LOCAL REVIEW BODY

CONTINUED PLANNING APPLICATION FOR REVIEW

**PROPOSED ERECTION OF RAISED DECKING AND BOUNDARY FENCE:
3 CARDROSS PLACE, GREENOCK (17/0186/IC)**

**RESUME CONSIDERATION OF A REQUEST FOR REVIEW OF REFUSAL OF
PLANNING PERMISSION WHICH THE LOCAL REVIEW BODY**

Client	Genie JA, David, & Caroline Price, Gwentkirk
Project Title	Proposed Extension of Timber Decking and Boundary Fencing
Drawing Title	PLAN 177
Proposed Floor & Elevation	Side
Drawing No.	PL-05-177-002
Status	PLAN
Scale	1:50
PLANNING

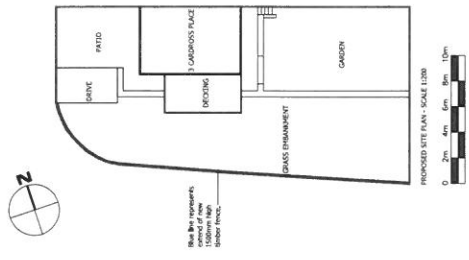
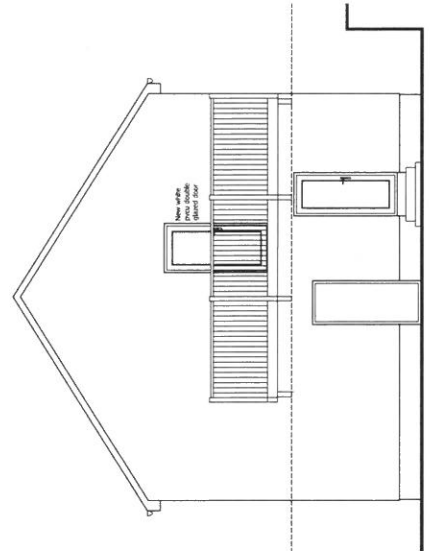
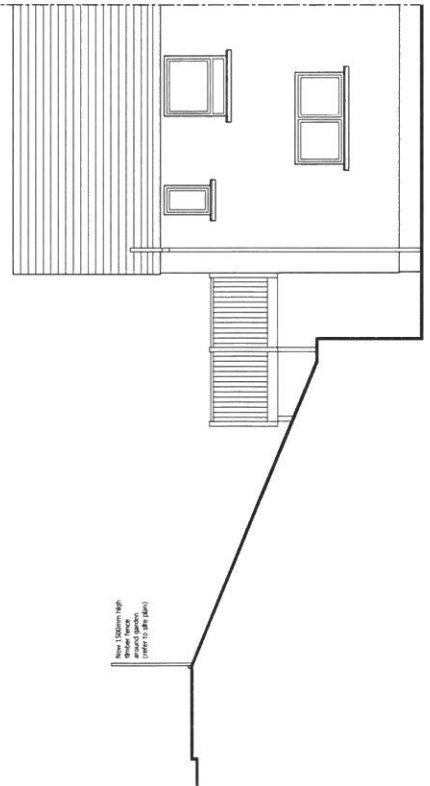
1. The proposed new fence will replace an existing fence. The new fence is on the boundary line of the property which is different from the existing fence. The visibility splay from Cardross Place to Clynder Road appears to be 2.4m by 30.0m with the new fenceline. This is acceptable as traffic is likely to be travelling slowly from the dead end on Clynder Road toward Cardross Place.
2. The new fence also continues up to the driveway. The type of fence proposed provides no visibility of pedestrians on the footway or vehicles entering Cardross Place from Clynder Road. This is not acceptable. The applicant should lower the fence to 1.0m high from the driveway for a distance of approximately 40m.

1. The design and position of the raised decking has a detrimental impact on the streetscape and the character and amenity of the area, contrary to Policy RES1 and Policy RES5 of the Inverclyde Local Development Plan.
2. The position and height of the boundary fence has a detrimental impact on road safety at the junction of Cardross Place and Clynder Road, contrary to Policy RES5 of the Inverclyde Local Development Plan.

Reference to these comments in the Report of Handling (Appendix 7) made by the case officer state that the advice is to lower the fence to 1.0 metre in height for a distance of 40metres from the driveway. The lowered height will only intensify the concerns regarding visibility of the proposals as well as overlooking/privacy implications. The distance of 40 metres is incorrect and should only be 4 metres. If the fence was only reduced over a distance of 4 metres, then the 1500mm high fence erected over the remainder of the side garden will still provide screening and assist with providing privacy from the street. Any pedestrians using the pavement on Clynder Road are unlikely to see the decking due to the height of the fence.

Client	Glenview Street, Glenview, PA 19137
Project Title	Proposed Erection of Timber Decking and Boundary Fence
Drawing Title	Plan
Proposed Date & Drawn	25.06.17
Drawn by	RL
Checked by	AL
Scale	1:50
Sheet	PLANNING

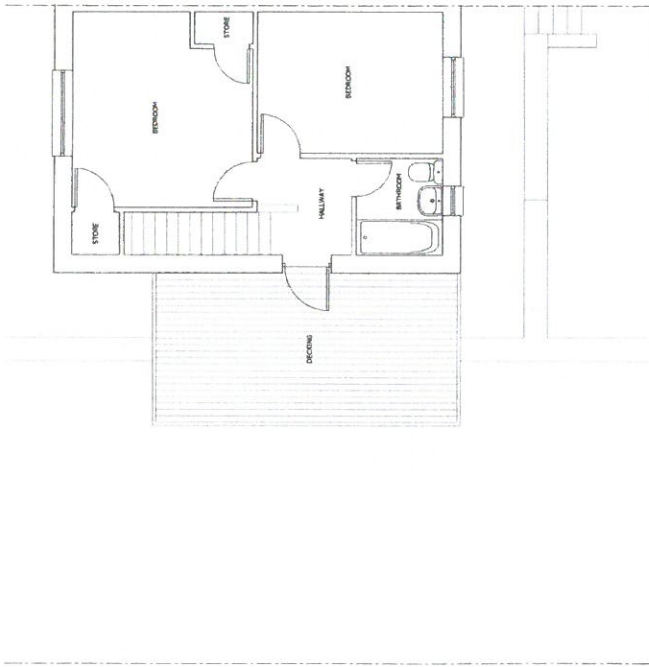
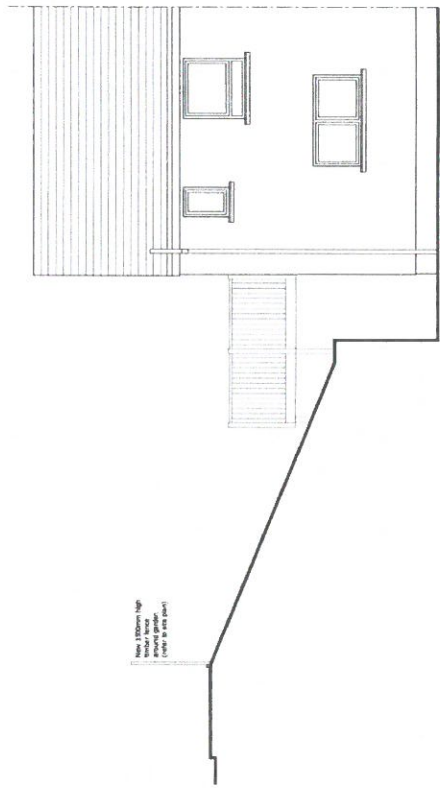
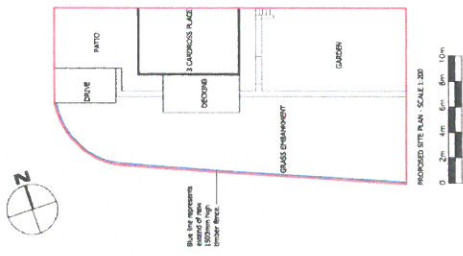
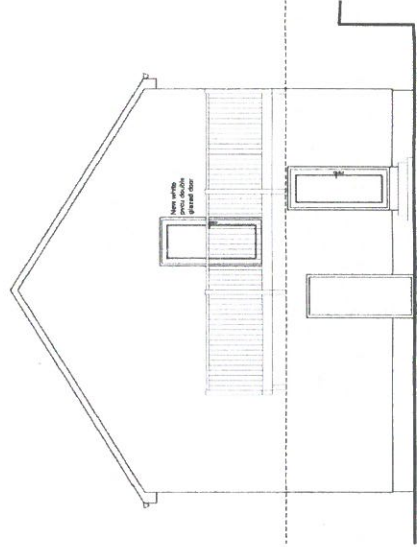
1. The proposed new fence will replace an existing fence. The new fence is on the boundary line of the property which is different from the existing fence. The visibility splay from Cardross Place to Clynder Road appears to be 2.4m by 30.0m with the new fenceline. This is acceptable as traffic is likely to be travelling slowly from the dead end on Clynder Road toward Cardross Place.
2. The new fence also continues up to the driveway. The type of fence proposed provides no visibility of pedestrians on the footway or vehicles entering Cardross Place from Clynder Road. This is not acceptable. The applicant should lower the fence to 1.0m high from the driveway for a distance of approximately 40m.

1. The design and position of the raised decking has a detrimental impact on the streetscape and the character and amenity of the area, contrary to Policy RES1 and Policy RES5 of the Inverclyde Local Development Plan.
2. The position and height of the boundary fence has a detrimental impact on road safety at the junction of Cardross Place and Clynder Road, contrary to Policy RES5 of the Inverclyde Local Development Plan.
